RE: SUBMISSION ON THE METROLINK ON BEHALF OF ESPRIT INVESTMENTS LIMITED IN RELATION TO PROPERTY AT TOWNSEND STREET AND SHAW STREET, 32-33 PEARSE STREET, AND 36-37 PEARSE STREET, DUBLIN 2.

ABP Ref. NA29N.314724

Technical Comments re:Metrolink railway order

Proposed alignment in relation to our client's property (alignment drawing rotated for ease of comparison)

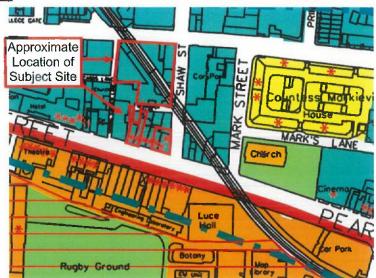
Our client also has a concern in relation to the assessment and quantification of the impacts contained within the submitted documentation, as our client's property (and the permitted and future buildings to be constructed thereon) has not been specifically assessed, only a neighbouring building. This is especially concerning given that the proposed alignment runs directly under our client's property.

Figure 1 Section View

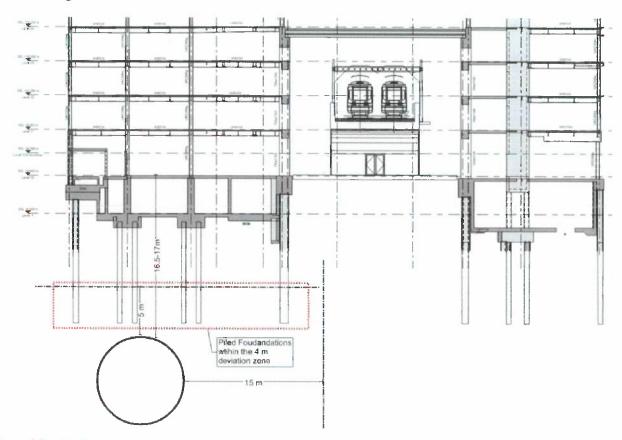
The Railway Order applies for a vertical deviation of 5 metres. Whilst it is understood a deviation may be required due to detailed design or conditions encountered, the result of such a deviation in relation to the subject property is potential clashes with substructure and increased impacts arising in relation to noise, vibration and associated building damage.

We note that 15m plan deviation or 10 metres downward deviation will not have significant impact to the constructed basement works and the project.

However, a deviation of 5m upwards would clash with the constructed piled foundations at ML6O-U26. See Figure 1.

We expect that the requirement of deviation of the underground tunnel to be clarified by TII/Metrolink technical team at the location underside of our building, whether this is only for a possible grout injection works that would require. As part of the previous agreements, TII/Metrolink is expected to confirm that the tunnelling works should be cognisant of the asconstructed underground structures.
